# Staff Report

**To:** Salt Lake City Planning Commission  
**From:** Olivia Cvetko, Principal Planner  
[Olivia.Cvetko@slcgov.com](mailto:Olivia.Cvetko@slcgov.com) | 801-535-7285  
**Date:** December 21, 2023  
**Re:** PLNZAD2023-00837, 3<sup>rd</sup> East Variance

## VARIANCE

**PROPERTY ADDRESS:** 649 S 300 E  
**PARCEL ID:** 16-06-386-003-0000  
**MASTER PLAN:** Central Community Master Plan  
**ZONING DISTRICT:** RMF-35 (Moderate Density Multi-Family Residential)

Image showing the proposed site plan and allowed building envelope per RMF-35 zoning requirements.

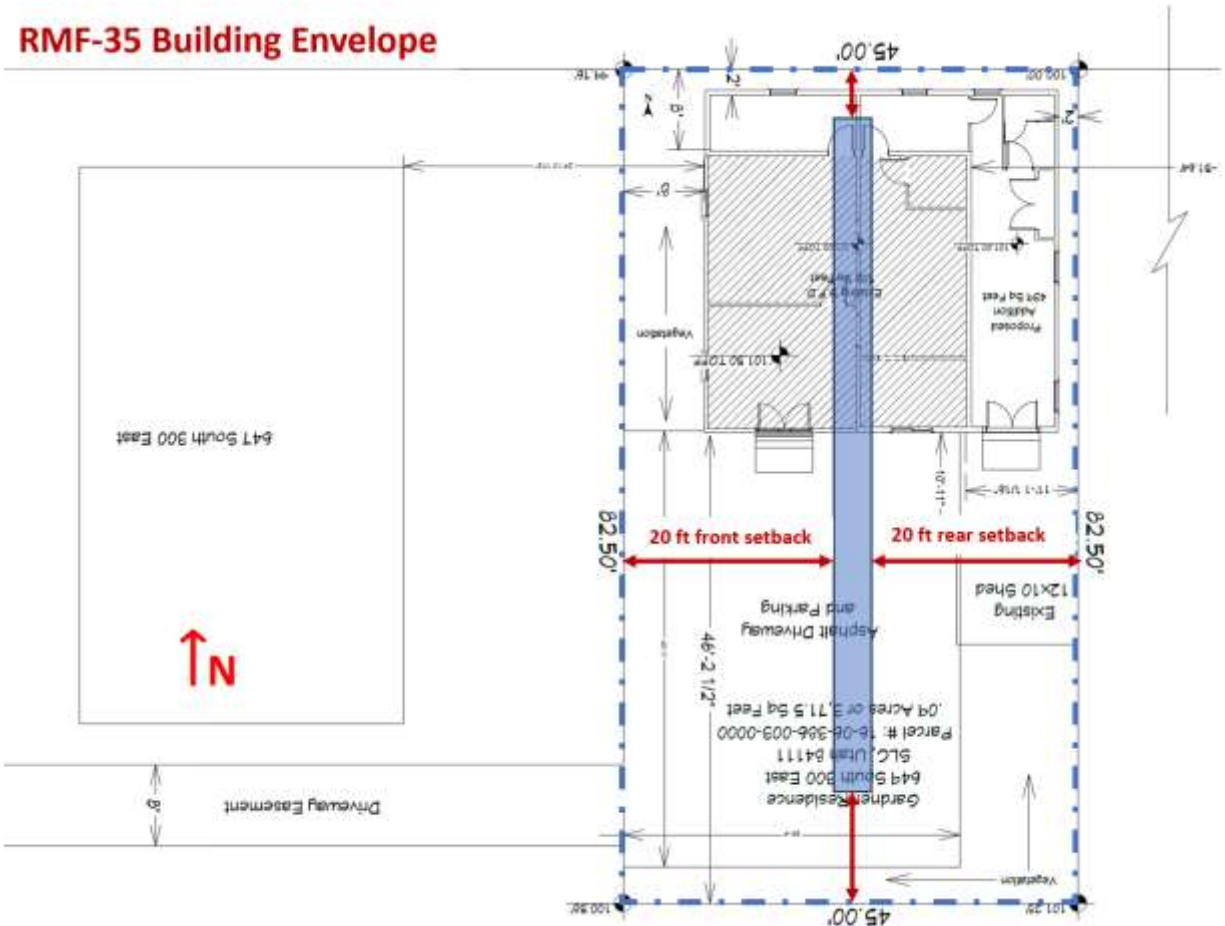
Because the front property line is to the west, the lot is considered 45 ft deep and 82.5 ft wide. The required rear and front yard setback for lots in the RMF-35 zone are each 20 ft, leaving a buildable area of 5 ft deep and 68.5 ft wide. The following table provides the dimensions of the property and building setbacks in relation to current zoning regulations, followed by an image provided by Planning Staff showing the building envelope per the RMF-35 zone setbacks on this lot.

RMF-35 Standard	Existing	Proposed
<b>Front Yard Setback</b> 20 ft	8 ft	NA
<b>Side Yard Setback</b> 4 ft, 10 ft	46 ft (South) 8 ft (North)	NA (South) 2 ft (North)
<b>Rear Yard Setback</b> 25% of lot depth with minimum of 20 ft	11 ft	2 ft

Image showing a vehicle turnaround with parking provided by the Transportation Division.

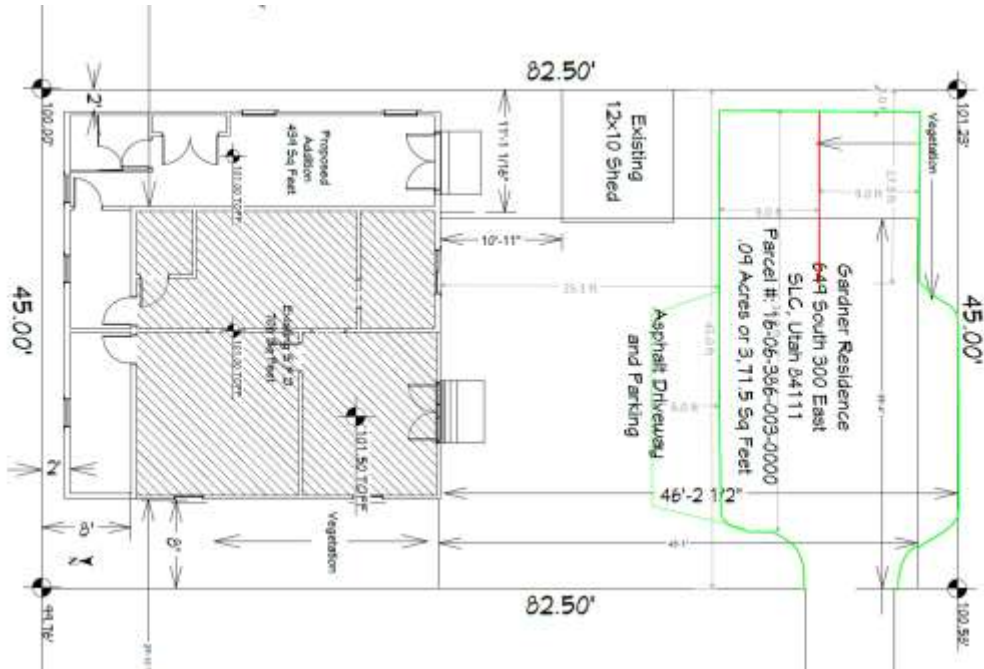
The applicant has stated that the home is unusual for the area, being landlocked facing south with access from the west, necessitates the entire area south of the home for parking and turnaround to exit the private drive. While staff acknowledges the distinct characteristics of the lot, an evaluation based on dimensions for a vehicle turnaround indicates sufficient space to

accommodate an in-line addition, as shown below and verified by the Transportation Division. Considering the existing code provisions allow for an addition to the home, a variance is not necessary.

Image showing area appropriate buildable area with an in-line addition to a noncomplying structure (does not account for lot coverage maximums or parking area requirements).

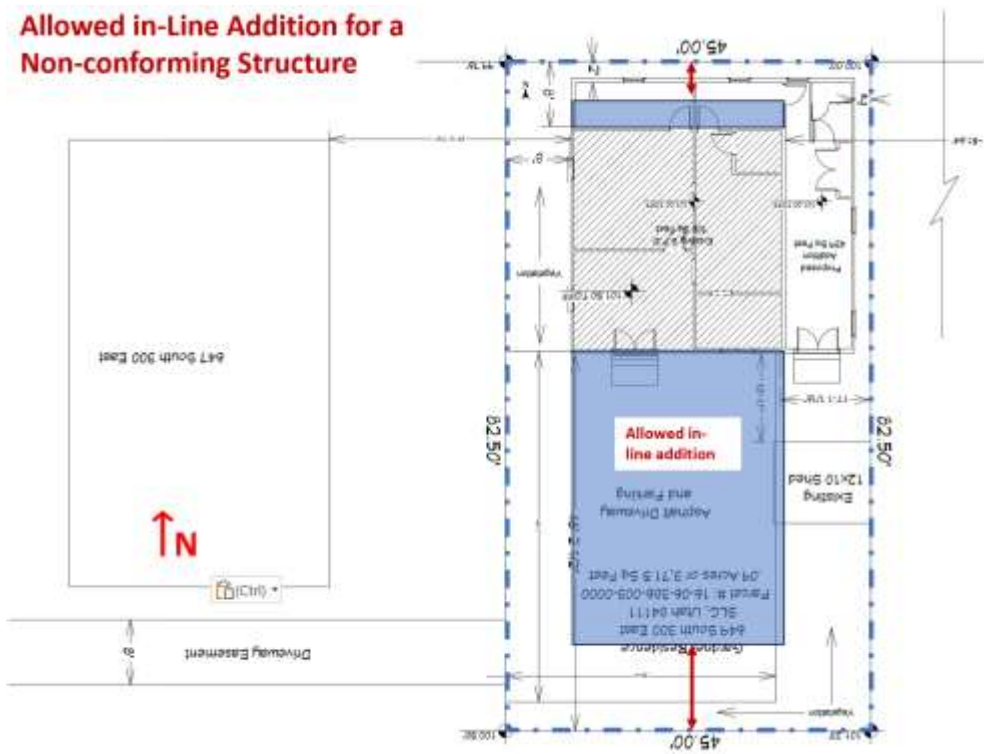
**Minimal Variance Necessary:** Variances should only be granted if, "it is not greater than the minimum variation necessary to relieve the unnecessary hardship demonstrated by the applicant." In reviewing the application materials and site plan, it appears there is adequate space to accommodate an addition to the south side of this home.
